June 2, 1986
(NMP2L 0730)

Re: Nine Mile Point Unit 2
Docket No. 50-410

This letter is in response to the Nuclear Regulatory Commission Project Manager's letter dated May 8, 1985 concerning compliance to Regulatory Guide 1.75 as discussed in Niagara Mohawk's report entitled "Failure Mode and Effect Analysis."

ENCLOSURE

FIGURE 1. HPCS BYPASS VALVE POSITION INDICATION POWER SUPPLY

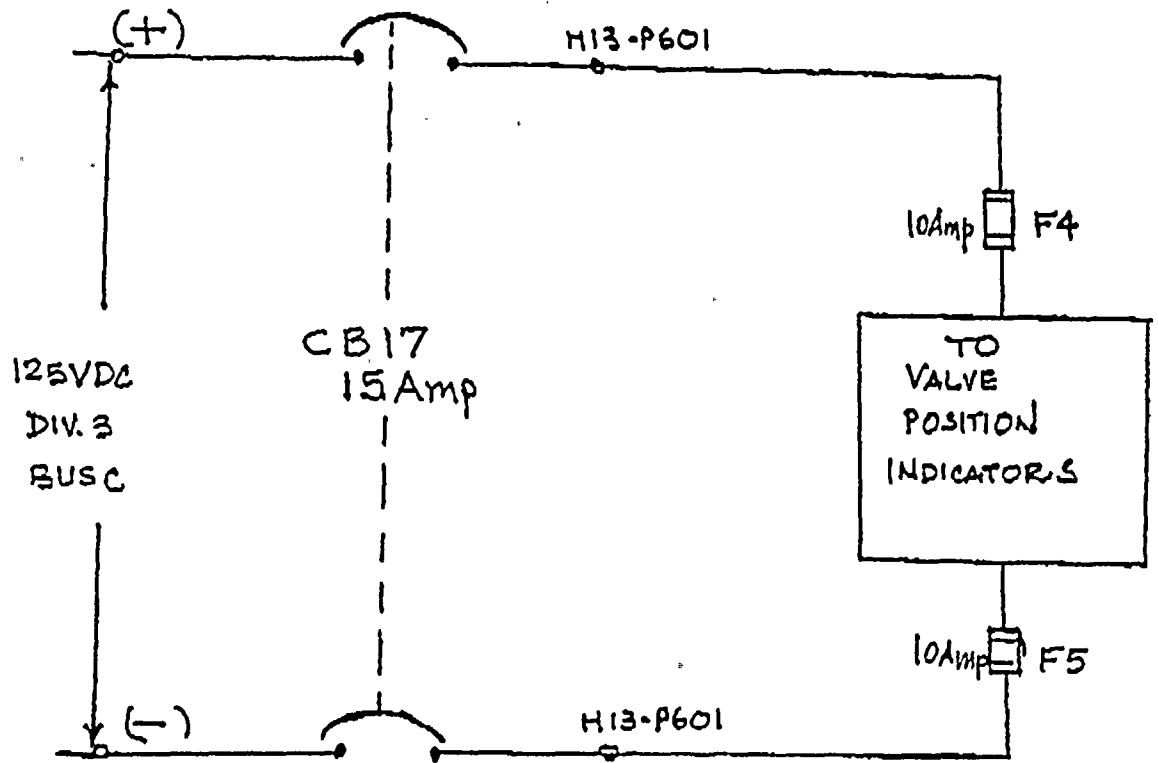
2. Comment: Justify the use of non-Class 1E components for High Pressure Core Spray (HPCS) bypass valve position indication or provide Class 1E components for this position indication.

Response: Two Class 1E resistors (E22-R21, R22) will be installed in the HPCS test valve position indication circuit. This will be accomplished prior to startup after the mini-outage.

The high pressure core spray test bypass valves E22-F010 and F011 position indication circuits are powered from a Class 1E supply. The circuit uses 250 Ω non-1E resistors E22A-R21, R22 as voltage divider to adjust the range of the electrical signal for valve position indicators E22-R606, R604. The valve position indication function by itself does not initiate or prevent the core spray pump operation and is not essential for mitigating a LOCA event. The position indication provides operator information during system testing. If the indication is unavailable and the bypass valve is inadvertently left open following a system test and the HPCS is required to operate, the valves are automatically closed. Sufficient other indications are available to the operator to assure proper valve line-up and flow into the vessel. Such indications are:

Based on the above discussion, it is concluded that the valves will be properly positioned and there are enough alternate means available for operator information, assuming the loss of the bypass valve indication, due to failure of the non-Class 1E resistor. Also, there is no detrimental effect to the system safety function.

The power supply circuit for the position indications is fed from Division 3, 125Vdc bus, via 10 amp fuses E22B-F4, F5, non-Class 1E, each in series with a 15 amp, double pole, Class 1E circuit breaker (E22B-CB17). Thus, in the event of a failure of the indication circuit causing a low impedance fault (short across +ve and -ve terminals), the faulted circuit will be isolated by opening of one or more of these protective devices without degrading the Class 1E bus. Thus, there will be no safety impact on the electrical power system. Refer to Figure 1 for simplified circuit representation.
